From: Norman Hopkins [norman@amyhrf.org]
Sent: Wednesday, January 25, 2012 10:10 AM
To: Docket, Hearing; Flyntz, Matthew
Subject: Federal Register 77561, Contention 4A
Attachments: Florida Register77561.pdf

Limited Appearance Statements Related to Contention 4A - Federal Register 77561

Kings Bay Saltiness⁽³⁸⁾

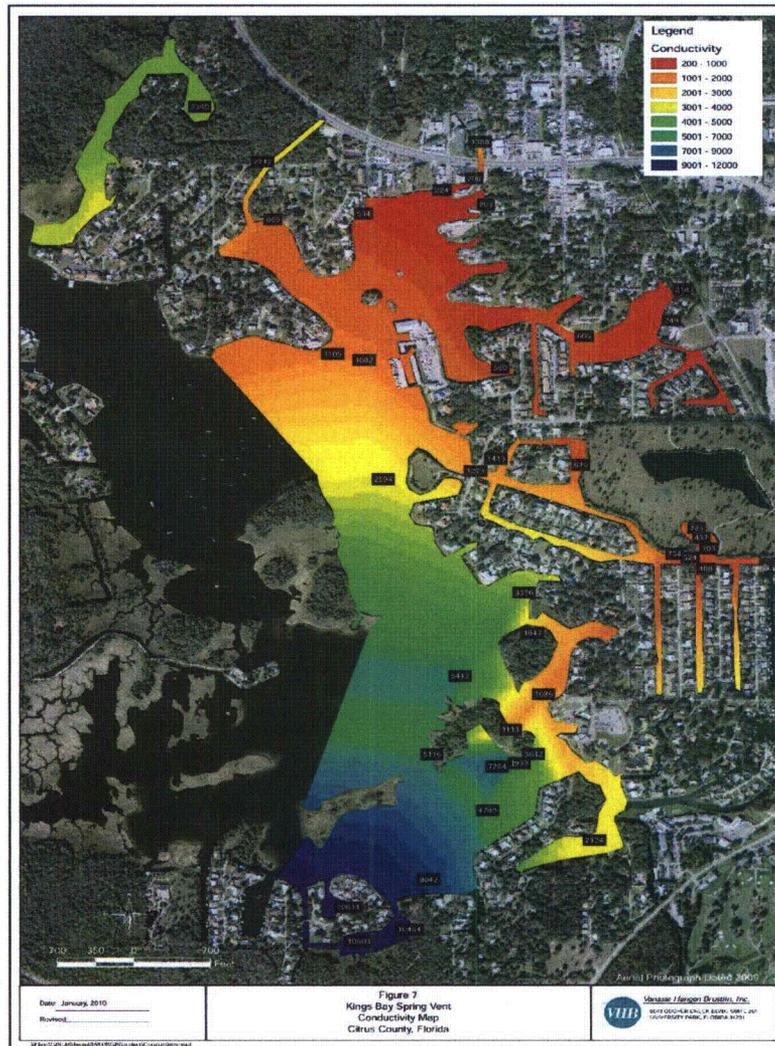
Moreover, studies⁽³⁸⁾ show that increases in saltiness from some spring discharges are already happening as the result of up-welling as depicted as Kings Bay Saltiness on the next page following.

The principal underground tributary flows of the aquifer contribute to the phenomenon⁽⁸⁾. The Aquifer tributary flow trending SE to NW serving spring vents in the south of Kings Bay experiences excessive pumping from a large housing complex on its path. The Aquifer tributary flow trending NE to SW serving spring vents in the north and east sectors of Kings Bay appears to by-pass any such pumping and have significantly lower levels of saltiness.
